RE: KILN NO. 2 INDIRECT FIRING MODIFICATION
TARMAC FLORIDA, INC.
PENNSUCO PLANT

Re: Kiln No. 2 Indirect Firing Modification
DEP File 0250020-007-AC (PSD-FL-142A)

Re: Permit Application for Kiln No. 2 Indirect Firing Modification (0250020-007-AC)

Figure 1: Direct Firing

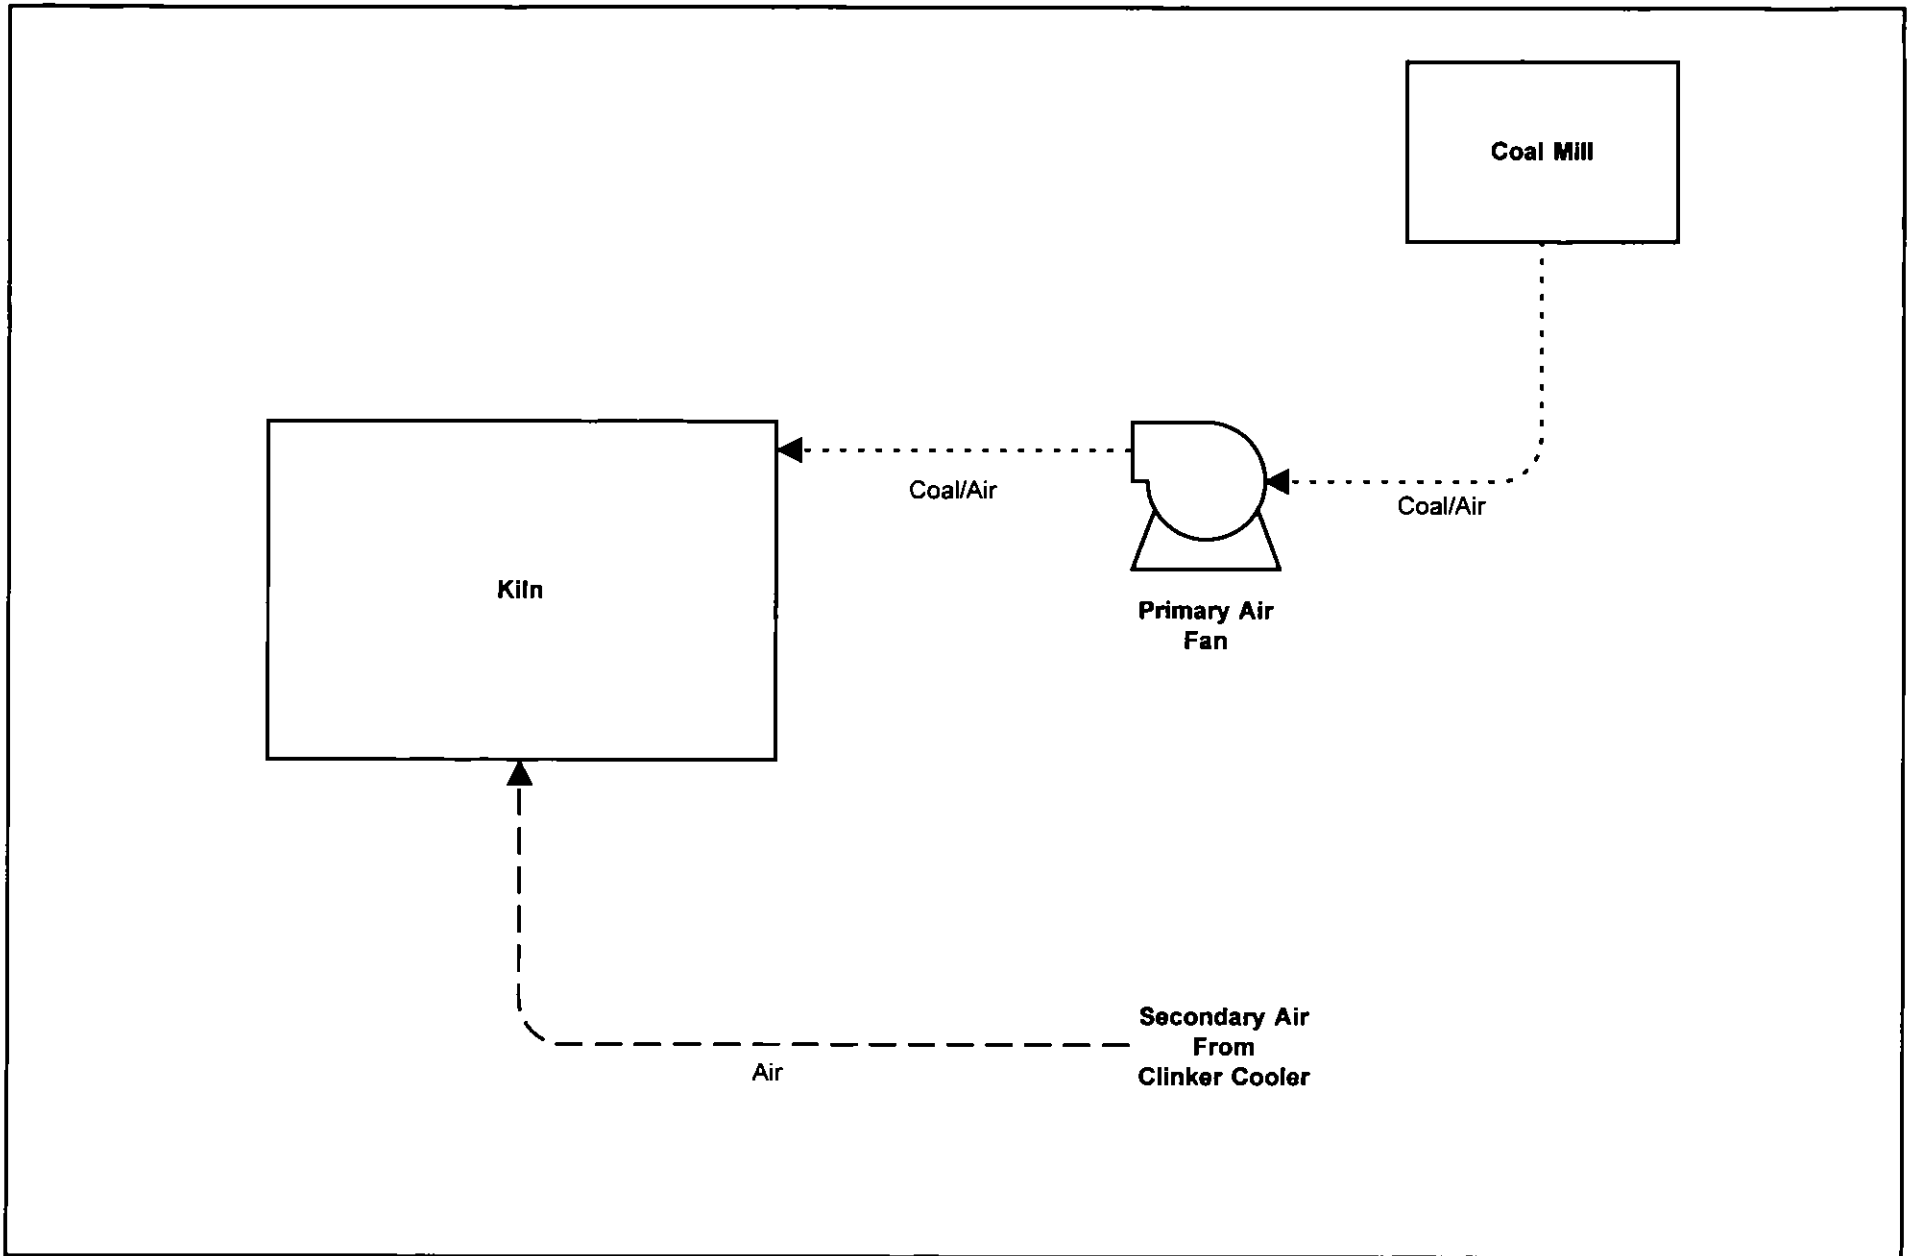
The physical change to indirect firing is portrayed in the attached flow diagrams. In the present direct firing method (Figure 1), coal from the coal mill is sent directly to Kiln No. 2 via the primary air fan. The primary air volume, which is a high volume flow, is determined by the amount of air needed to pneumatically convey the coal through the coal mill. The

primary air cannot be adjusted to result in lower emissions. Secondary air for the kiln is drawn from the clinker cooler.

Figure 2: Indirect Firing

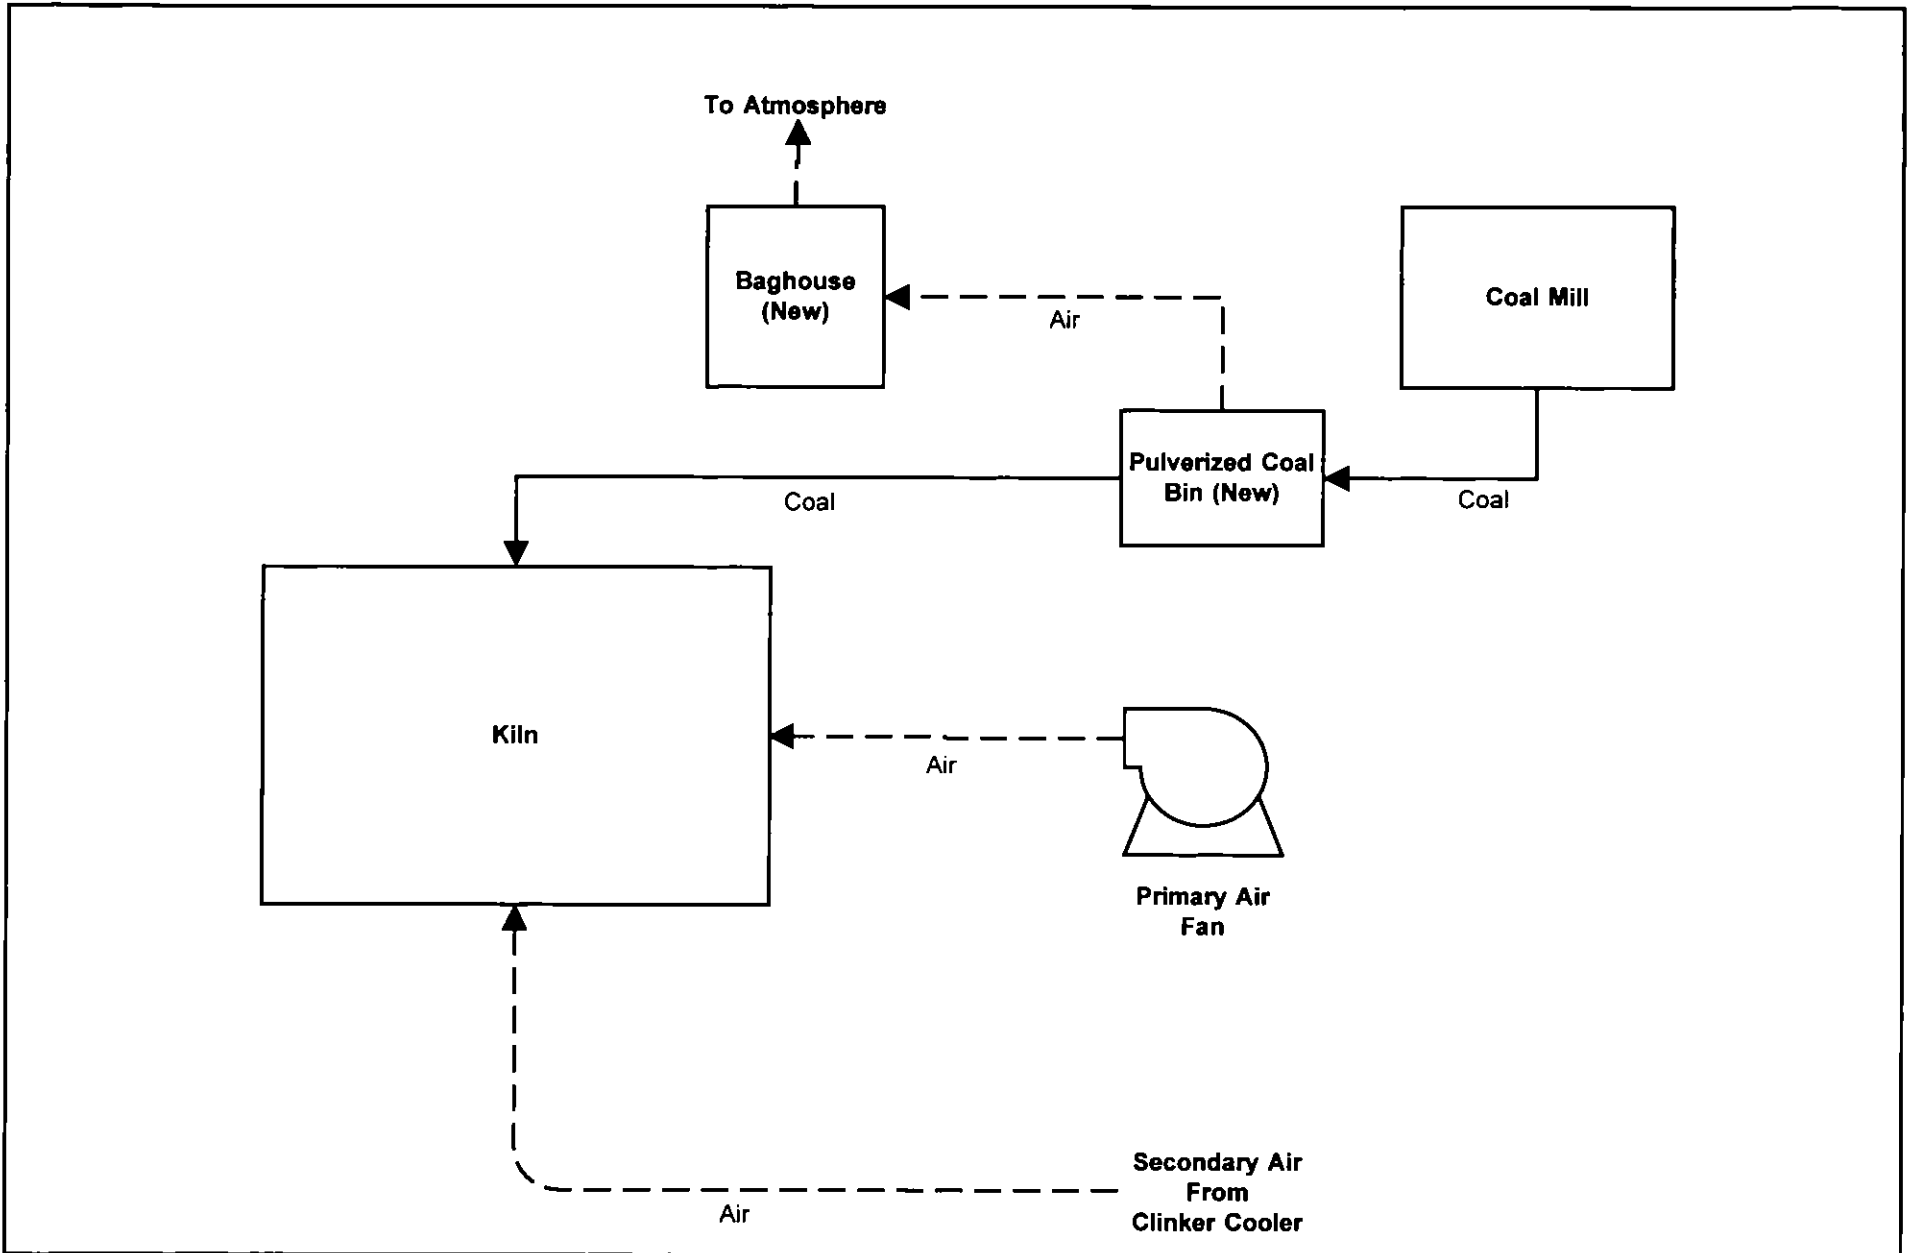
In the proposed indirect firing method (Figure 2), a pulverized coal bin (new) is added downstream of the coal mill. The air from the coal mill is exhausted through a baghouse (new) serving the coal bin. Pulverized coal from the coal bin is then sent to the kiln, separate from the primary combustion air. Although some air is needed for transporting the coal to the kiln, it is small compared to the air entering the kiln with the coal in the direct firing method. Primary air enters the kiln independently, and is controlled independently of the coal input or the secondary air input. Secondary air continues to be drawn from the clinker cooler. This greater control over the primary air to the kiln should result in substantial NO_x reductions.

No detailed engineering information is yet available for the proposed indirect firing method. However, the attached flow diagrams show the major changes.
